Title of Change:	Transfer assembly and test of Ultrafast and Planar Schottky rectifier products in TO220FP package from ON Semiconductor Vietnam (OSV) to SP Semiconductor & Communication Co., Ltd (SP Semi) with case outline change.																			
Proposed Changed Material First Ship Date:	29 August 2019																			
Contact information:	Contact your local ON Semiconductor Sales Office or <Phuong.Hoang@onsemi.com>																			
Samples:	Contact your local ON Semiconductor Sales Office or <PCN.samples@onsemi.com> Sample requests are to be submitted no later than 30 days from the date of first notification, Initial PCN or Final PCN, for this change. Samples delivery timing will be subject to request date, sample quantity and special customer packing/label requirements.																			
Additional Reliability Data:	Contact your local ON Semiconductor Sales Office or <Tam.Vu@onsemi.com>																			
Type of notification:	This is a Final Product/Process Change Notification (FPCN) sent to customers. FPCNs are issued 90 days prior to implementation of the change. ON Semiconductor will consider this change accepted, unless an inquiry is made in writing within 30 days

CASE 221D-03(SP Semi)

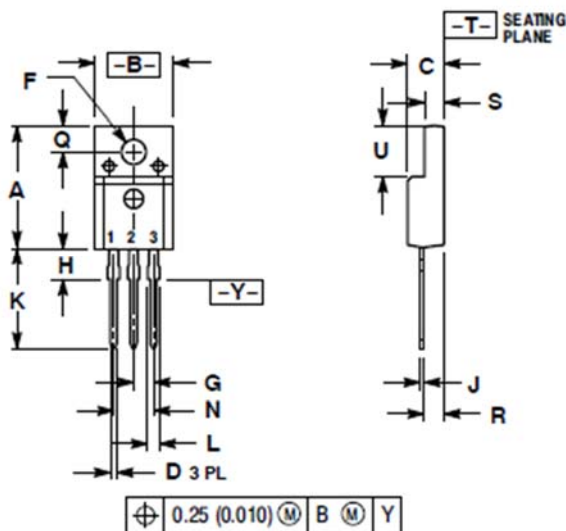
<table><tr> <th></th><th>Before Change Description</th><th>After Change Description</th></tr><tr> <td>Case outline</td><td>221AH</td><td>221D-03</td></tr></table>

Comparison between case outline

CASE 221D-03 (SP Semi)

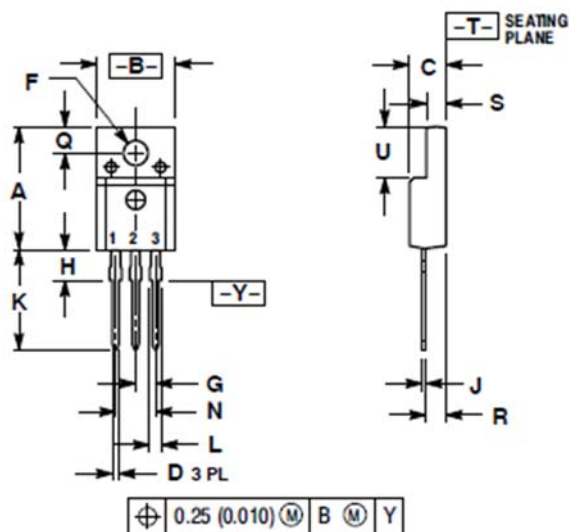
<table><tr> <th></th> <th>変更前の表記</th> <th>変更後の表記</th> </tr><tr> <td>ケース外形</td> <td>221AH</td> <td>221D-03</td> </tr></table>

ケース外形の比較
